Access Compliance Report

Public Rights-of-Way

Intersection ID: 49197	Main Street: GRAYPARK_DR	Cross Street: ALEXANDER_FOREST_DR	Location: W
ADA ID: 1179A2DFAA5E	Ramp Type: PerpDiag	Initial Pass/Fail: Fail	Overall Compliance: No
		Severity Score: 10

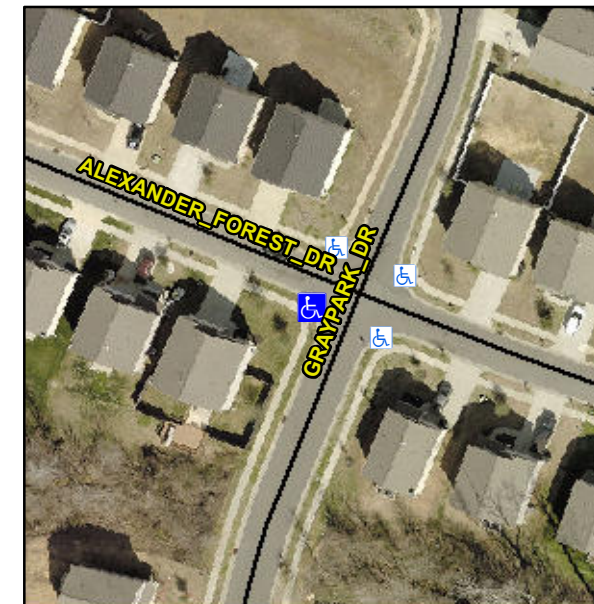
Not Found, R304.5.1, R304.5.3

Compliance	Description	Data	Compliance	Description	Data
N/A	Ramp Length (in)	48.0	Yes	Ramp Slope (%)	7.0
No	Ramp Width (in)	47.5	No	Ramp XSlope (%)	4.1
N/A	Flare Type LT	N/A	N/A	Flare Type RT	N/A
N/A	Flare Slope LT (%)	N/A	N/A	Flare Slope RT (%)	N/A
N/A	Flare Traversable LT?	N/A	N/A	Flare Traversable RT?	N/A
N/A	Landing Length (in)	N/A	N/A	DWS Provided?	N/A
N/A	Landing Width (in)	N/A	N/A	DWS Contrast?	N/A
N/A	Landing Slope (%)	N/A	N/A	DWS Length (in)	N/A
N/A	Landing X Slope (%)	N/A	N/A	DWS Full Width?	N/A
N/A	Landing Curb? (Y/N)	N/A	N/A	DWS Offset (in)	N/A
N/A	Shared Landing?	N/A			
N/A	Gutter Ponding?	N/A	N/A	Gutter Slope (%)	N/A
N/A	Gutter Lip Ht (in)	N/A	N/A	Gutter X Slope (%)	N/A
N/A	Painted X Walk1?	No	N/A	Painted X Walk2?	No
	X Walk 1 Direction	To SE		X Walk 2 Direction	To NE
N/A	X Walk 1 Width (in)	N/A	N/A	X Walk 2 Width (in)	N/A
	X Walk 1 Slope (%)	0.3		X Walk 2 Slope (%)	2.6
	X Walk 1 X Slope (%)	5.6		X Walk 2 X Slope (%)	1.8

Remove & Replace Curb Ramp With Two New Directional Ramps or Equivalent.
